REQUEST FOR ADDITIONAL INFORMATION REGARDING

DEGRADED VOLTAGE TIME DELAY SETPOINT

NEXTERA ENERGY SEABROOK, LLC

SEABROOK STATION, UNIT NO. 1

Figure 1 - Staff Confirmatory Review

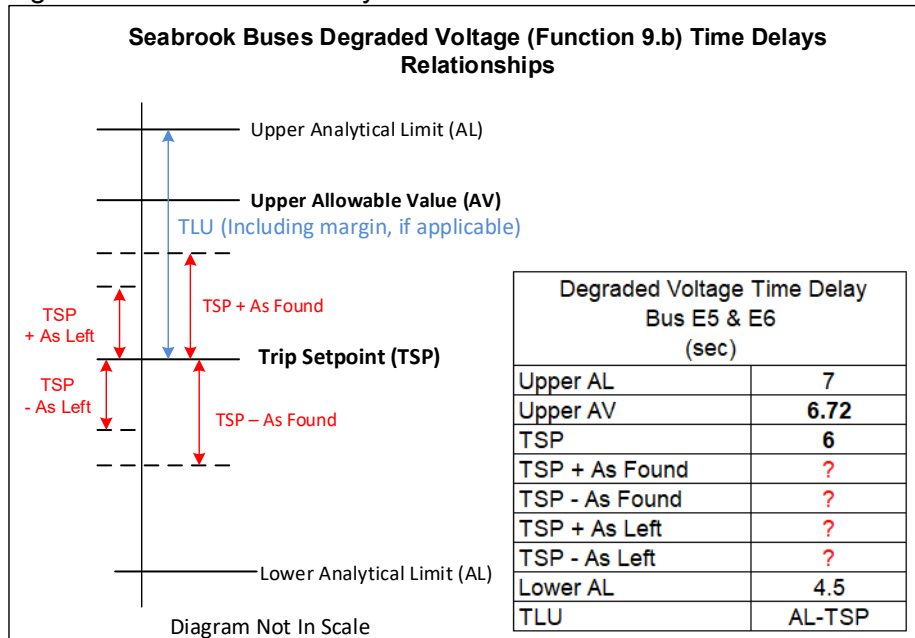
Provide a summary of the relevant calculation information that determined the new time delay setpoint for the 4.16 kV Bus 5 and 6 degraded voltage time delay relays, reducing the delay from a nominal 10 seconds (10.96 seconds allowable value) to 6 seconds (6.72 seconds allowable value). The summary should include the relay setting design basis, including the trip setpoint, the setting and tolerances to be used during calibration and required surveillances, the uncertainties associated with these settings, the expected relay drift between surveillances, measurement and test equipment uncertainties, and the as-found and as-left tolerance acceptance values to be applied during initial calibration and technical specification-related surveillances. Alternatively, the full setpoint uncertainty calculation may be provided for convenience but is not necessary.

This information is needed to enable the staff to understand the relationships among the trip setpoint, the as-left and as-found surveillance test acceptance criteria as further depicted below, in order to verify that the regulatory requirements and guidance above are being met regarding the selection and periodic surveillance of the setpoint and allowable time delay of Function 9.b. (Refer to Figure 1 below).

In the summary of the calculation, please indicate how the as-left and as-found surveillance test acceptance criteria were determined. This information is needed by the staff to evaluate whether key criteria within RIS 2006-17 are being met.
